project
PROPOSED ALTERATIONS TO
EXISTING DWELLING AT
VILLA FARM,
LUTTON GREENGATE,
LONG STATION

drawing
PRELIMINARY SKETCH

date	scale(s)
JUNE 94	1:50 1:100
job no	drg no
04/23	02A/C

GROUND FLOOR

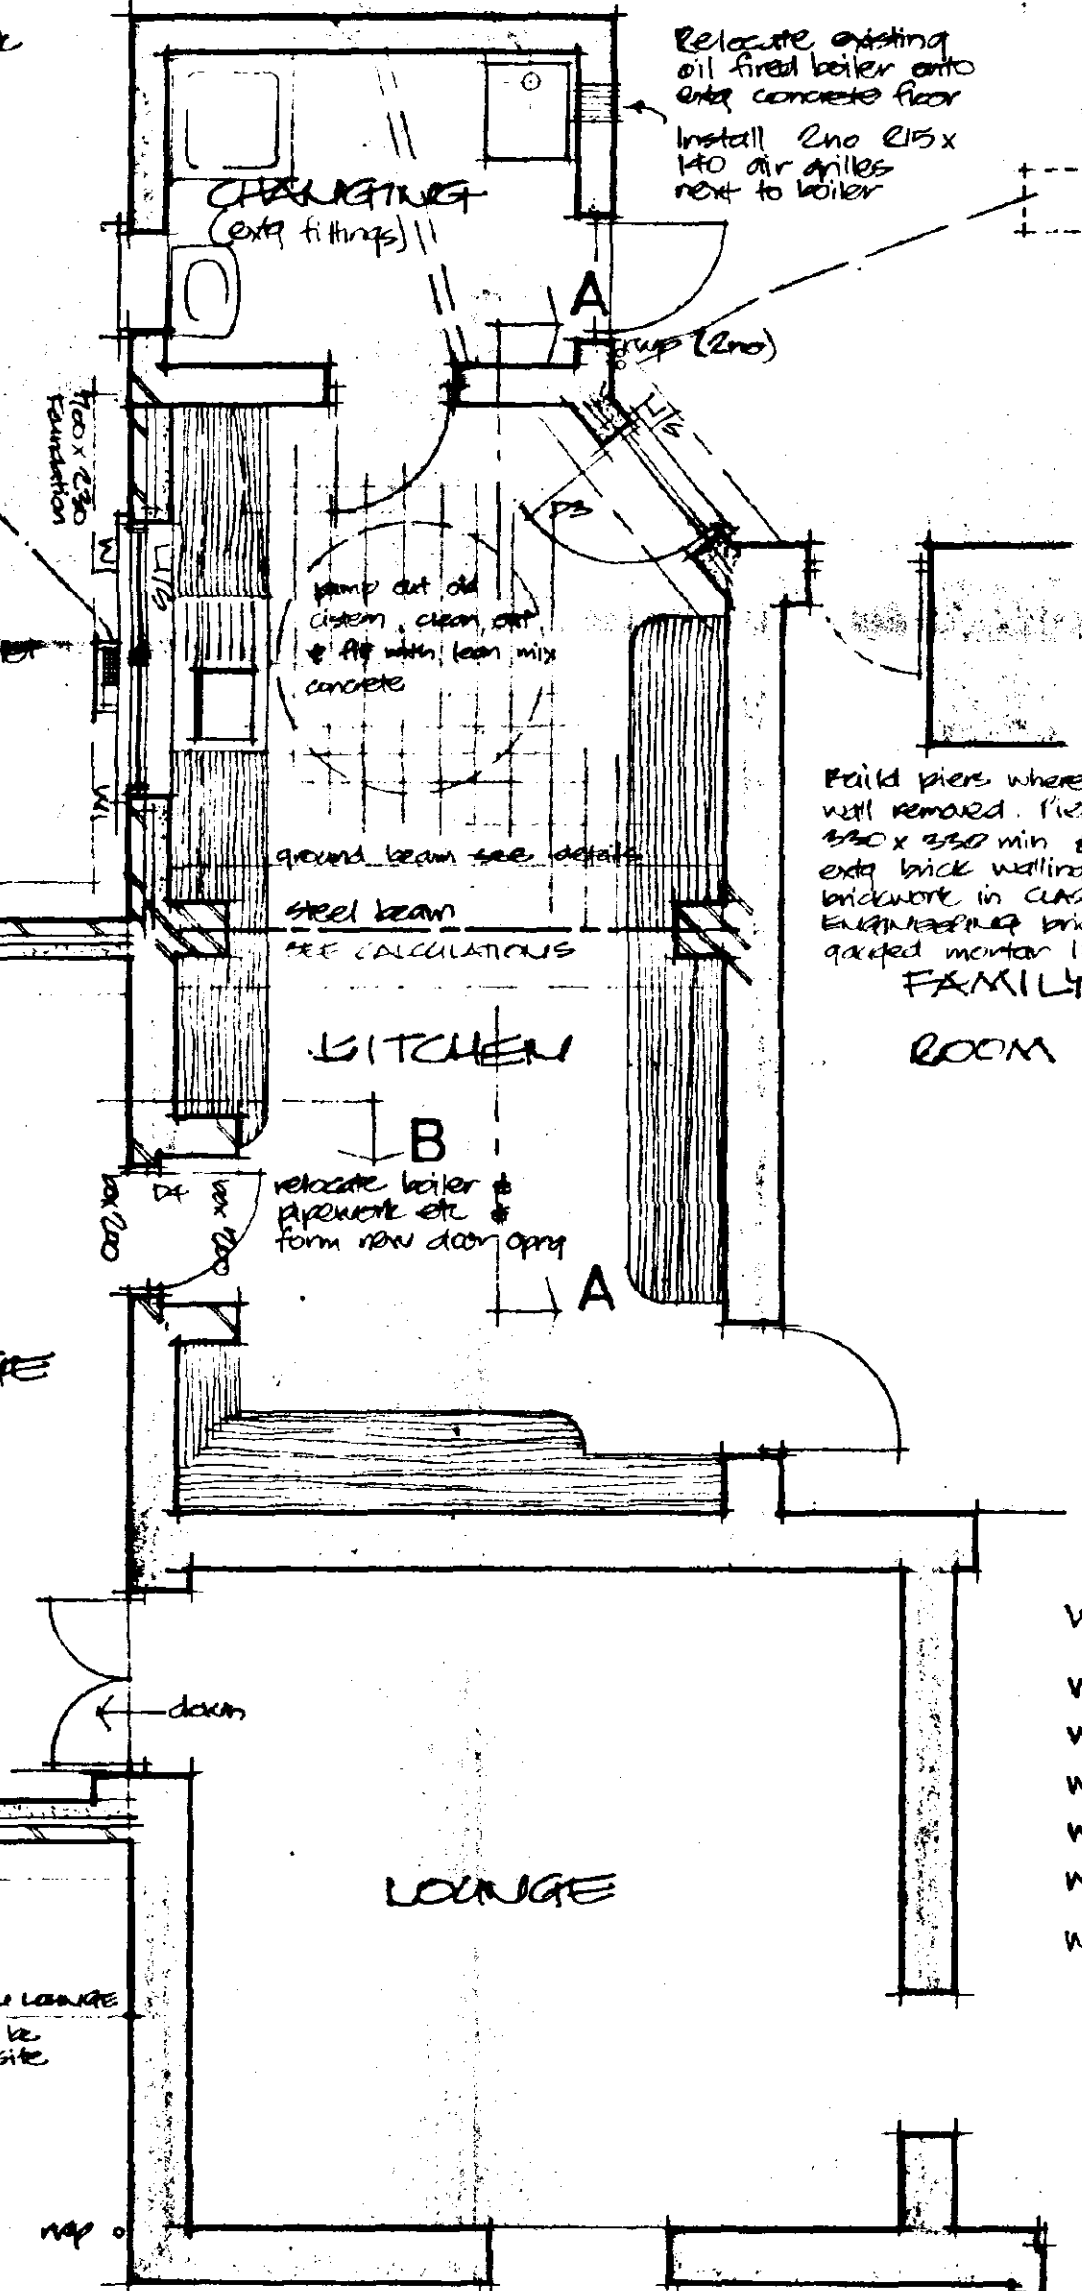
Notes:
To boiler install rigid stainless steel flue pipe assembly of internal flue diameter to match boiler exhaust outlet.
Where flue passes through roof construction provide insulated sleeve & clamping plate to support flue & externally provide stainless steel weathering plate.
Flue to extend min 1000mm above roof break & complete with flue terminal.

Remove brick wall, line & plaster out & generally make good to match exty incl. floor

Relocate existing oil fired boiler onto new concrete floor
Install 2no 215 x 140 air bricks next to boiler

connect rainwater down & run to exty rainwater system

connect to exty drain run
